MEMORANDUM

TO: District of Columbia Zoning Commission
FROM: *JL for* Jennifer Steingasser, Deputy Director, Development Review and Historic Preservation
DATE: November 25, 2015
SUBJECT: **ZC 14-24: Map Amendment from the R-4 to R-5-B Zone for Square 2848, Lots 39, 40, 72 and 838**

Figure 1

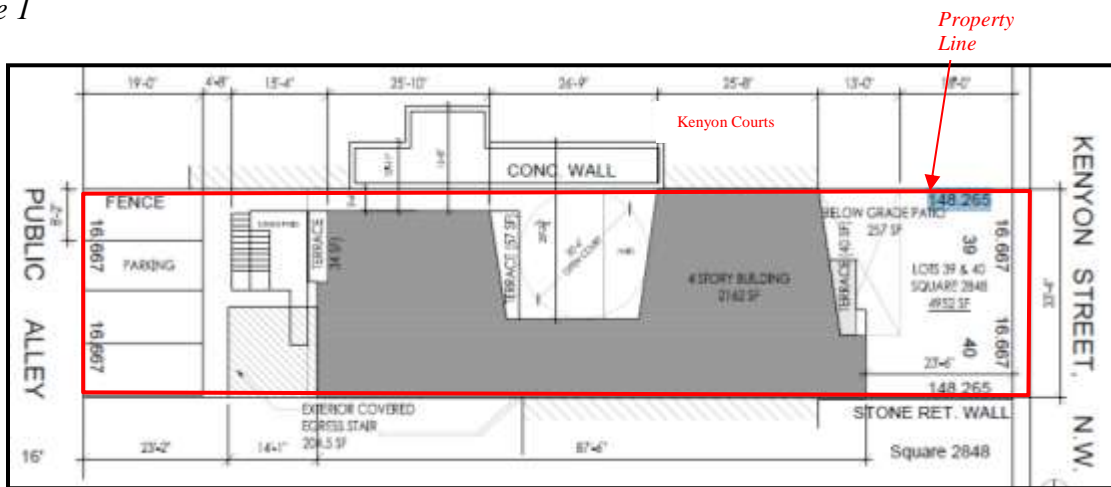
The Applicant has carved out an open area on the west side of the building similar to that on the building to the west, Kenyon Street Yes We Can Cooperative (*Figure 1 below*) to provide additional light and between the buildings. The Kenyon Street Yes We Can Cooperative building has a setback of between 7.41 feet and 13.12 feet from the property line and the proposed building would be setback an additional 3.5 feet to 24.66 feet from the property line. The setbacks combined would reduce clear sight views from the proposed development through to the windows on the Kenyon Street Yes We Can Cooperative building. Additionally, the terraces off the units which are in the court area are angled so that direct views to the windows on the adjacent building are minimized. Other terraces on the rear and the front of the units would not significantly impact the light to adjacent buildings to the east and south of the development.

The Applicant has provided light studies which show that the loss of light to the lower units on the Kenyon Street Yes We Can Cooperative building could be more affected by a matter-of-right R-4

development than the proposed development. To minimize the impact on the Kenyon Street Yes We Can Cooperative, the southern portion of the proposed building would be setback 3.5 feet from the property line as well as providing the court area adjacent to the existing court area on the Kenyon Street Yes We Can Cooperative building.

With the southern portion of the building setback from the property line, there have been concerns regarding the security of the units on the ground floor of the Kenyon Street Yes We Can Cooperative. Similarly, there is a concern for privacy of Kenyon Street Yes We Can Cooperative lower level units which would be adjacent to the open patios on the ground of the proposed building. To address both the privacy and the security issues, the applicant would build a fence along the Kenyon Street Yes We Can Cooperative open area. At the time of this report, the Applicant states that they are still in discussions with the Kenyon Street Yes We Can Cooperative as to their preference in the type, materials and height of the fence. The privacy of adjacent buildings to the east and south of the development would not be significantly impacted by due to the distance between the buildings.
